Falmouth Docks Development: Appropriate Assessment Addendum – Fal and Helford SAC

Project name **Falmouth Docks Development**
Project no. **1620015743-006**
Client **A&P Group**

Date 13/10/2025

Figure 7 – Proposed Dredge Areas in Relation to Areas of Maerl Habitat, Categorised as Living Maerl overlying Dead Maerl or Areas of Maerl in Sediment

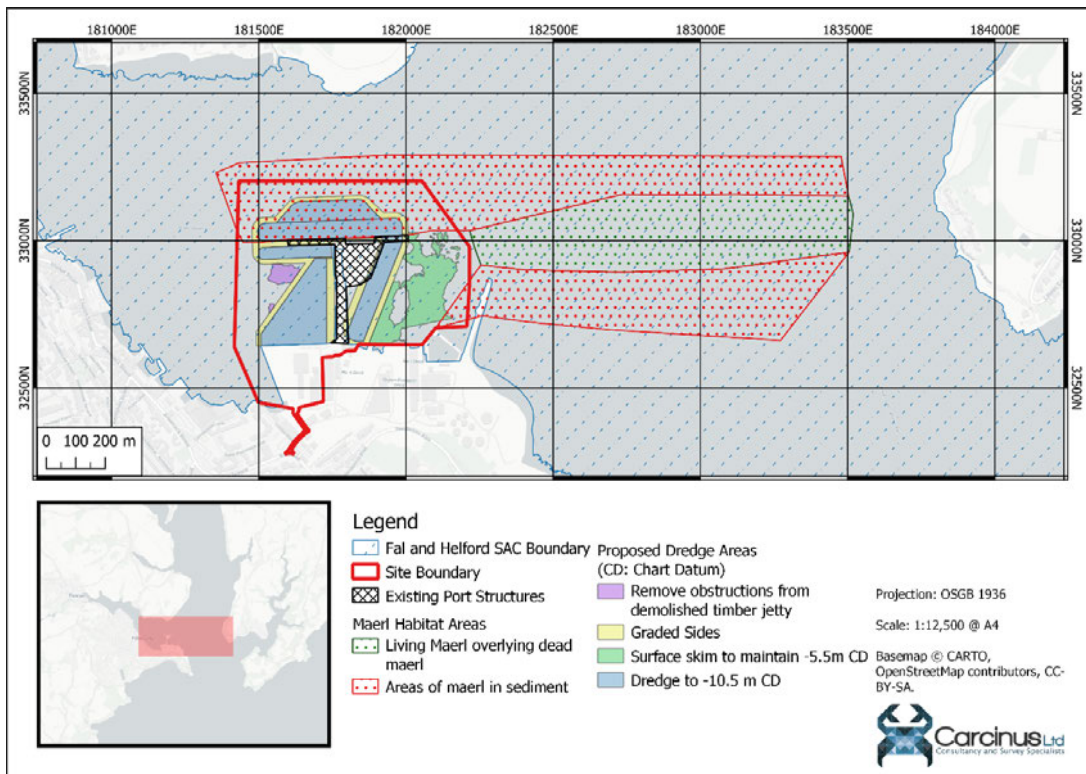
The survey data identified habitat types thought to be consistent with two of the descriptions above: living maerl overlying dead maerl and areas of maerl in sediment. These two habitat types are mapped and overlaid with the red line boundary (Figure 7). As there are no criteria for these descriptions there was not an opportunity to present a greater resolution within these two maerl habitat and thus some of the discrimination relies on the mapping shown in Figures 4-6 above.

Figure 8 - Sediment deposition (mm) at the end of the entire dredging campaign as a result of proposed dredging operations

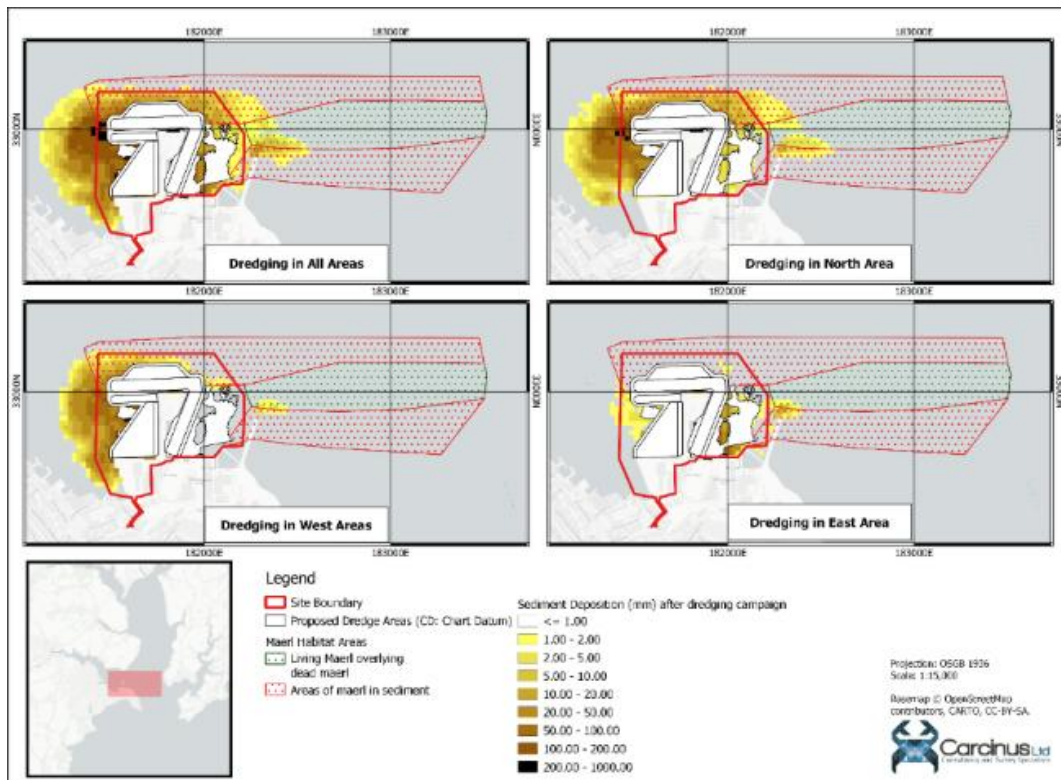
For both increased SSC and deposition the area of effect is predominantly within the project red line boundary, with some small areas to the north and east outside of the boundary. Modelled impacts show very limited zones of influence – as seen in Figure 8 of predicted sediment deposition from the entire dredge campaign, assuming no break in operations between the three dredge pockets.

Considering the limited extent of the ZOI for both pathways the mapping information is considered proportionate to the potential effects of SSC and deposition. However, the following brings together the key figures and includes some additional information to demonstrate the approach and outcome of the pressure mapping that support the conclusion of no AEOSI in the HRA from the dredge campaign.

Figure 9 - Ecological Receptor Locations for detailed review of SSC and deposition from dredge campaign

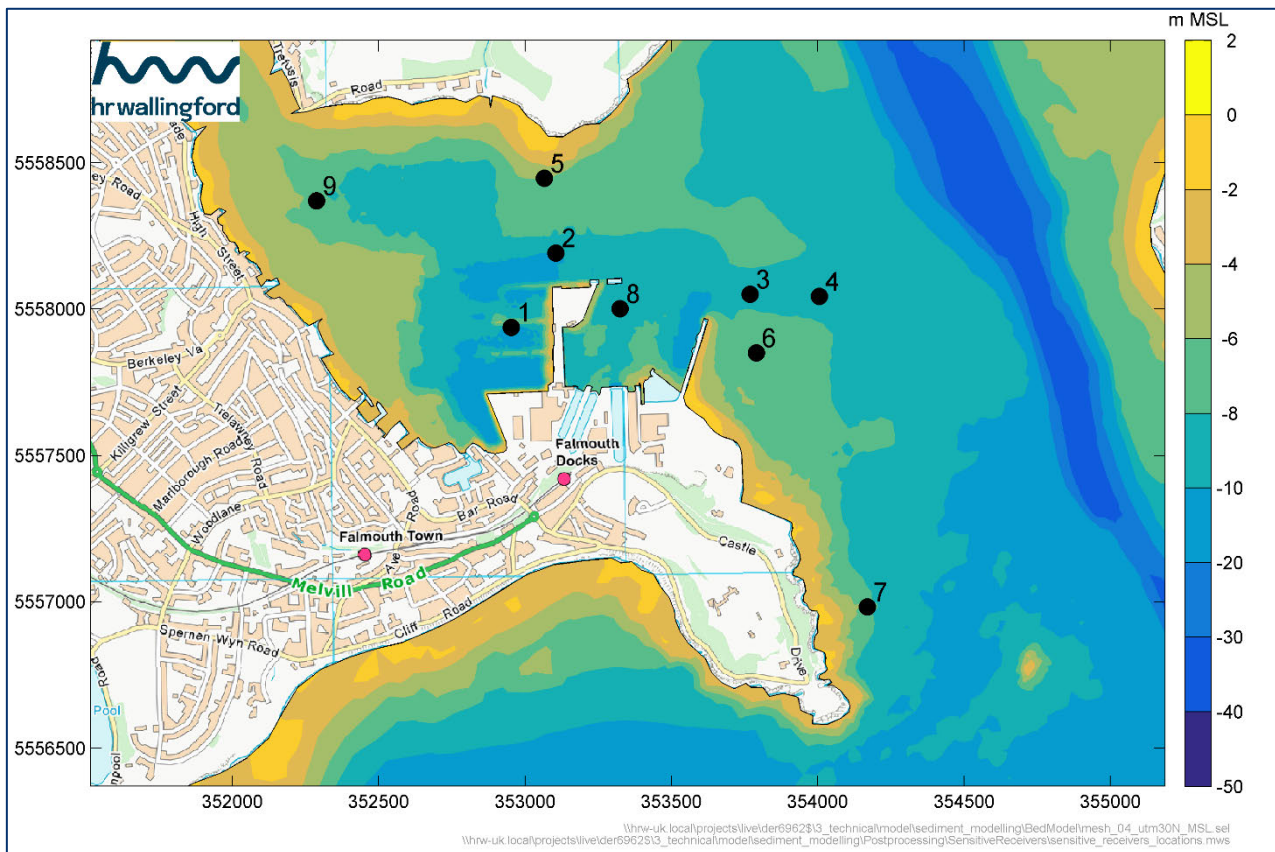
Habitat mapping also allowed the identification of nine key ecological receptor locations, shown in Figure 9 (ES Chapter 9) to investigate in more detail suspended sediment concentration and deposition values, for the key habitats in the project area. Habitats considered to be more sensitive include seagrass beds, kelp and maerl and the reasons for the selection of the sites are provide below.

- Sites 1, 2 and 8: located within the western, northern and eastern berth pockets;
- Sites 3 and 4: located in positions where maerl habitat had been identified, including in a region of live maerl cover;
- Site 5: located in proximity to seagrass and kelp habitats to the north, off Flushing Headland (see Figure 3);
- Site 6: located at the position of maerl south-east of the Eastern Breakwater, based on historical data;
- Site 7: located near the southern extent of the modelled sediment dispersion, albeit without the adopted mitigation measures; and
- Site 9: north-west of the site boundary, outside the predicted ZOI.

Figure 10 - Maximum increase in suspended sediment concentrations resulting from proposed dredging operations in each of the three areas

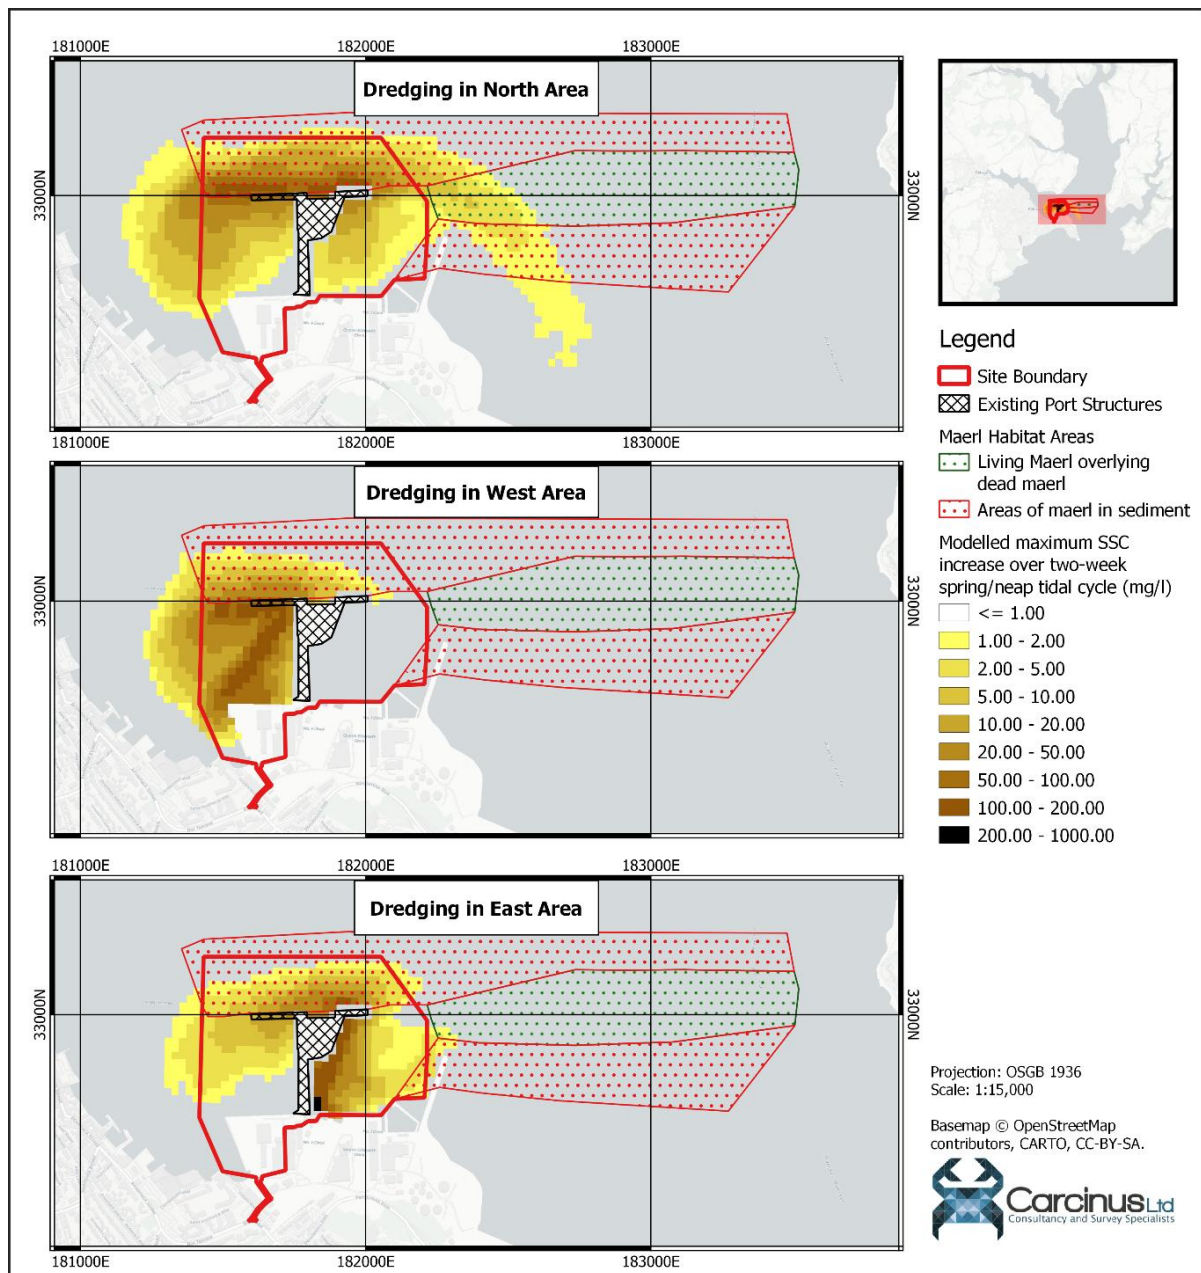
The modelling results for increases in SSC were mapped showing the maximum increase in suspended sediment concentrations resulting from proposed dredging operations in each of the three areas (Figure 10). With the exception of the dredge campaign in the north area, increases in SSC are largely contained within the docks.

Despite the fact that there would therefore be a daily spike in SSC during that time, the maximum increases in SSC at all modelled receptor locations are not higher than periodic storm events and average SSC values are within the ambient range. The restriction of dredging to certain tidal states significantly minimises the spatial extent of this plume, and SSC peak values are expected to be within natural variation. Sediment plumes are limited to within 300 m of the dredged area and are, on average, largely confined to the area within the site boundary. Where the plume extends beyond the site boundary the concentration modelled is very low (Figure 10, Dredging in North Area panel).

However, these contour plots can be misleading as they appear to represent an actual plume, when in reality the figure shows the maximum values that can occur across the whole dredge programme, not what occurs every time dredging takes place or what occurs all of the time.

Figure 11 - Mean increase in suspended sediment concentrations resulting from proposed dredging operations in each of the three areas (Maerl Technical Note)

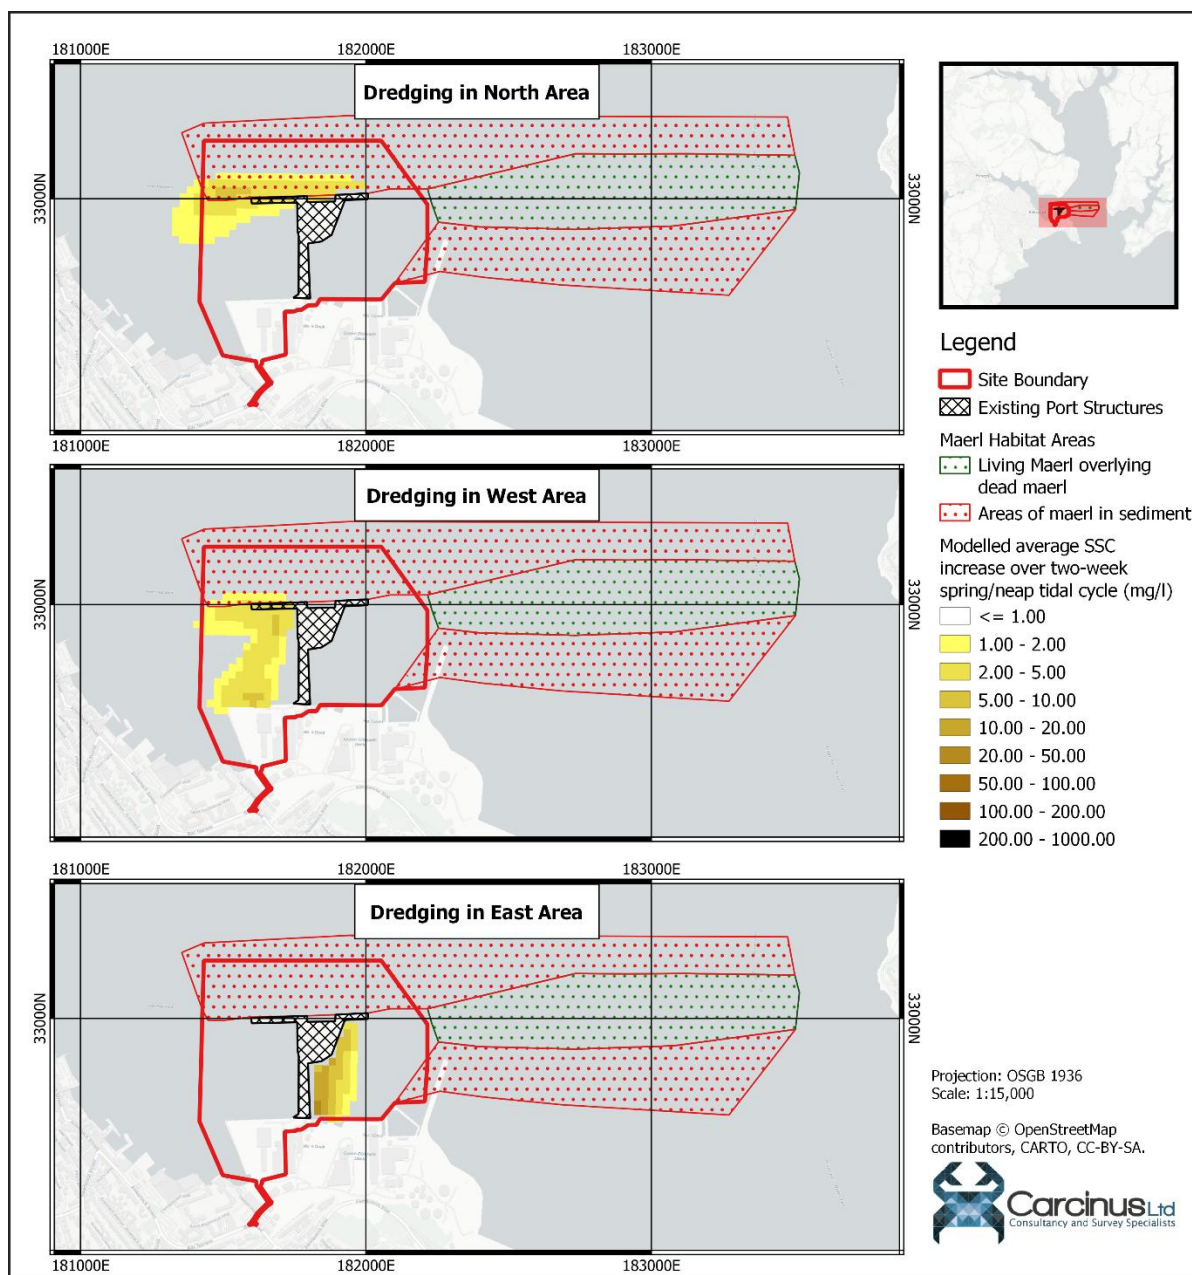
In addition, maximum values generally occur only occasionally and represent the worst-case scenario for the assessment. The mean SSC values, shown in Figure 11 below, are considered to be more representative of the general increase in SSC from dredging for most of the time across the whole campaign. However, both maximum and mean SSC plots, mapped together with the site boundary and the sensitive maerl habitat show that the ZOI for SSC would be largely restricted to the site boundary.

Figure 12 – Time series of predicted increase in suspended sediment concentration, for all nine receptor sites. Dredging in the north of the site

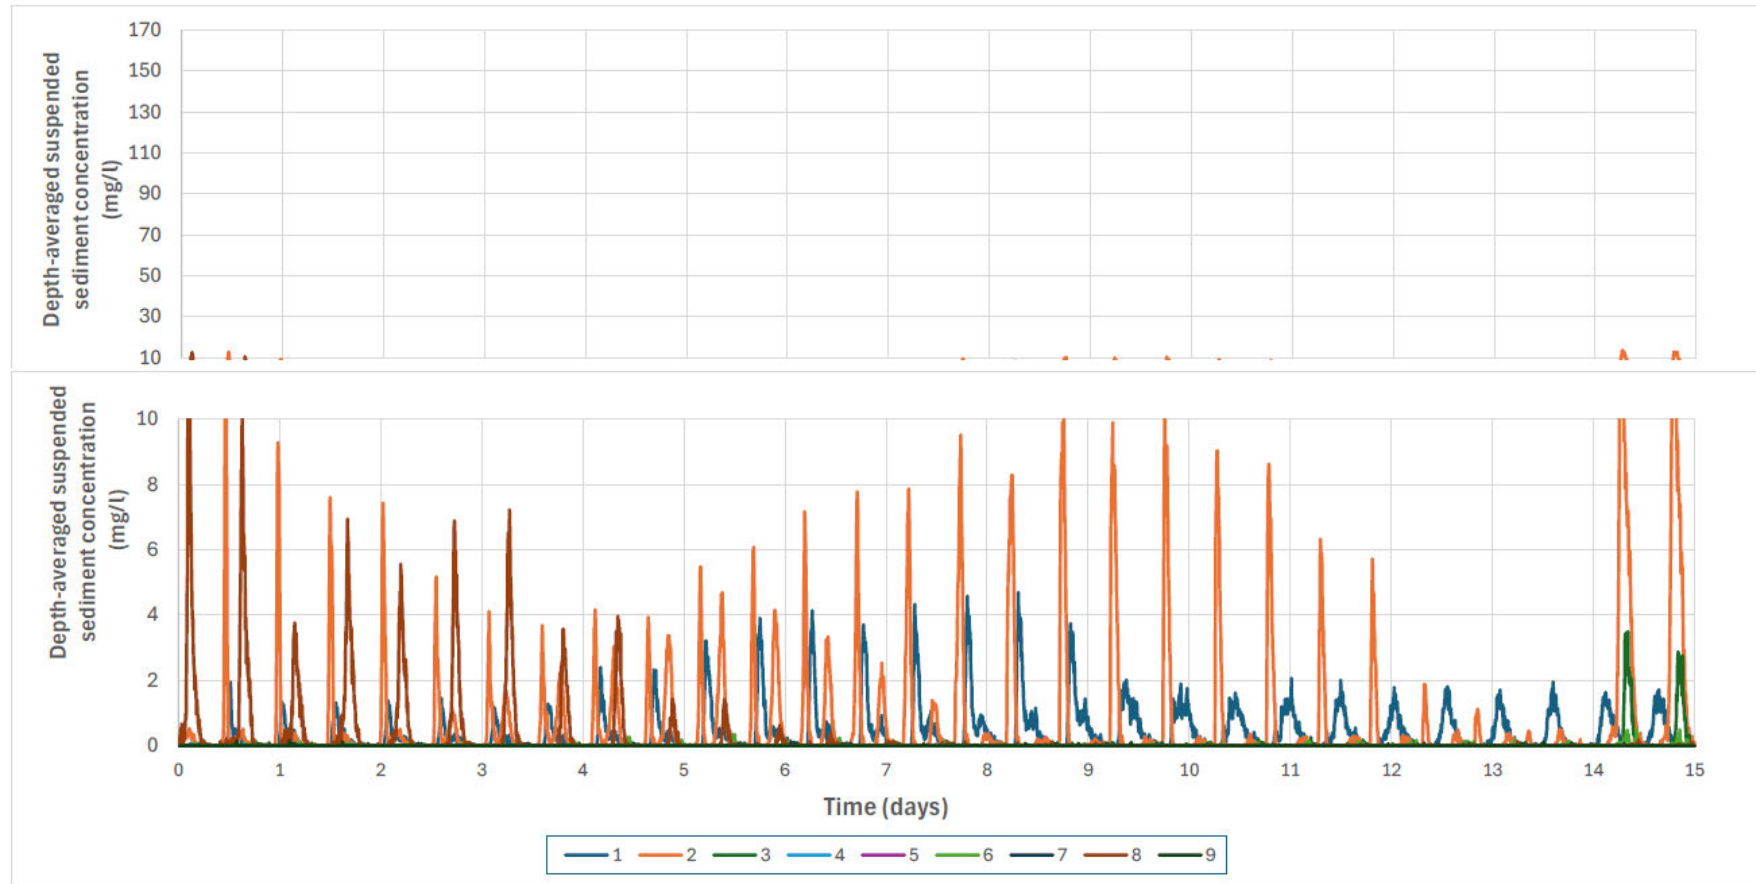
Three time-series figures, one for each of the dredge areas were provided in Technical Appendix 6.3, which was submitted with the application, but they were not specifically presented in the HRA report. As an example, the time-series for SSC from dredging in the northern area (the worst-case area) is shown in Figure 12.

However, teasing out the information for individual locations from this plot is difficult. Therefore, to supplement the HRA timeseries plots for SSC levels, additional plots have now been produced, one for each of the nine receptor sites, to supplement the assessment of SSC effects on the SAC.

Note that in the original timeseries, right at the end of the timeseries (after 14.5 days of dredging) the model erroneously switched to being all tide, showing artificial high peaks at the end of the plot in Figure 12. The location specific plots in Figure 13 to Figure 15 have therefore been stopped at 14.2 days.

Figure 13 - Location 2 showing SSC time-series for dredging in west (top), north (middle) and east (bottom) over a 2-week spring-neaps tidal cycle

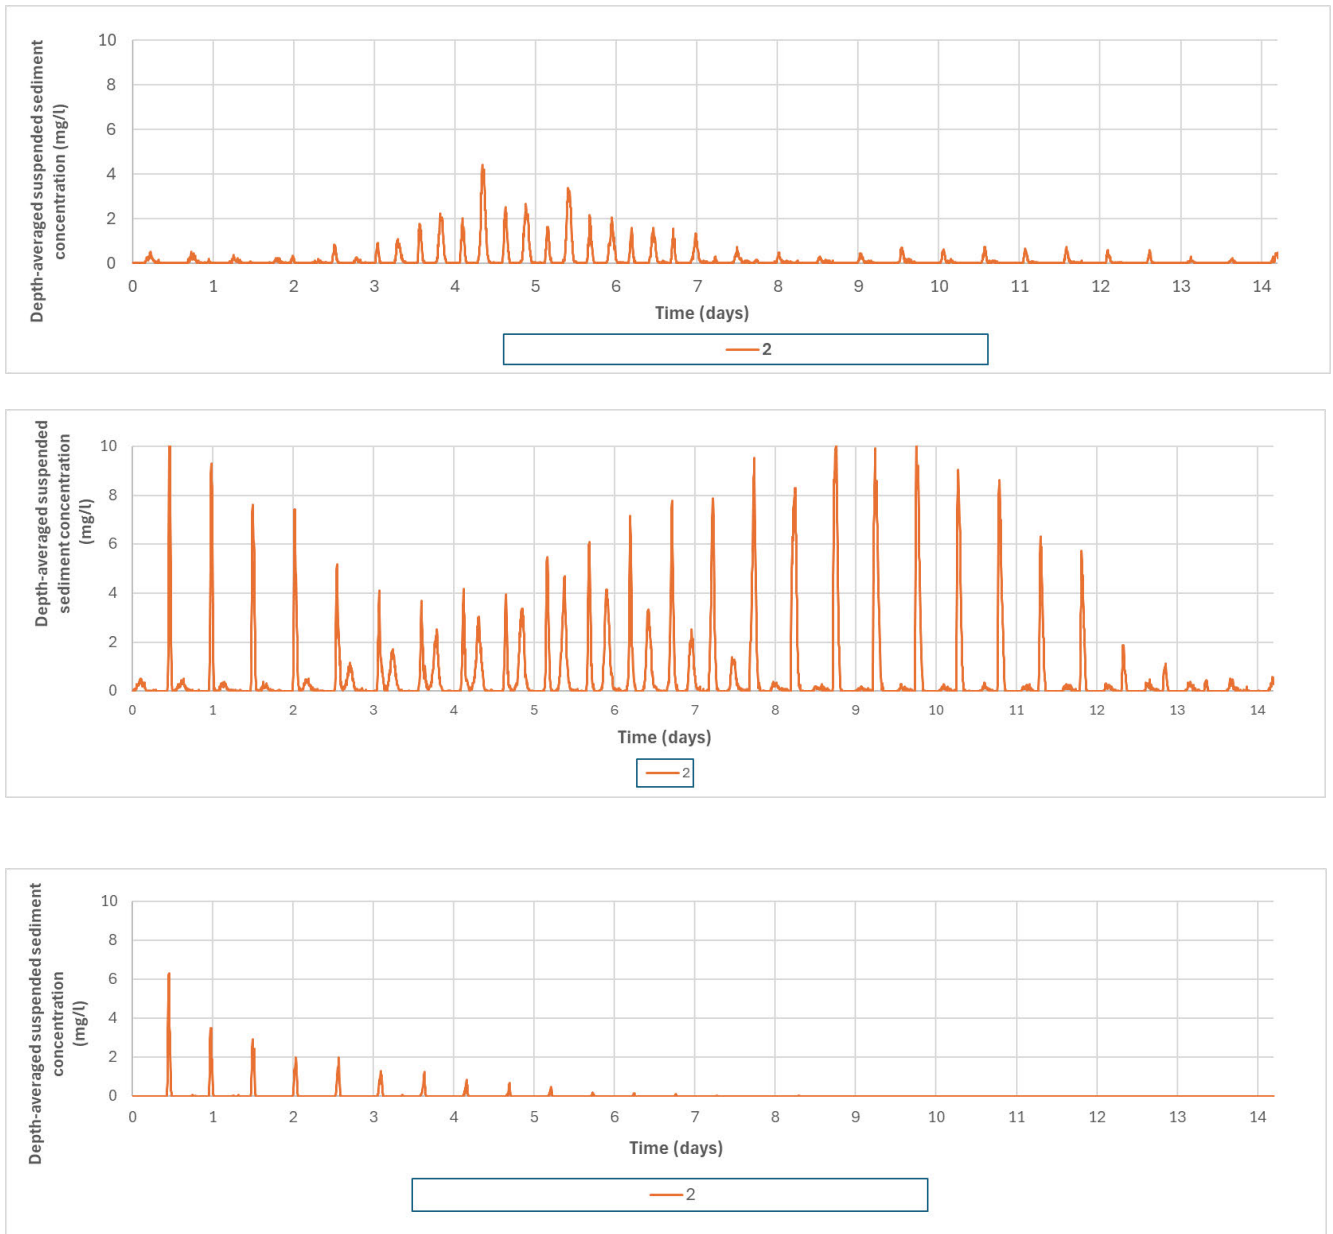
Site 2, immediately to the north of the northern berth pocket but within the site boundary has SSC values up to just over 10 mg/l (Figure 13) but only during part of the tidal cycle and the plots show the peaks are short-lived, rapidly returning to baseline.
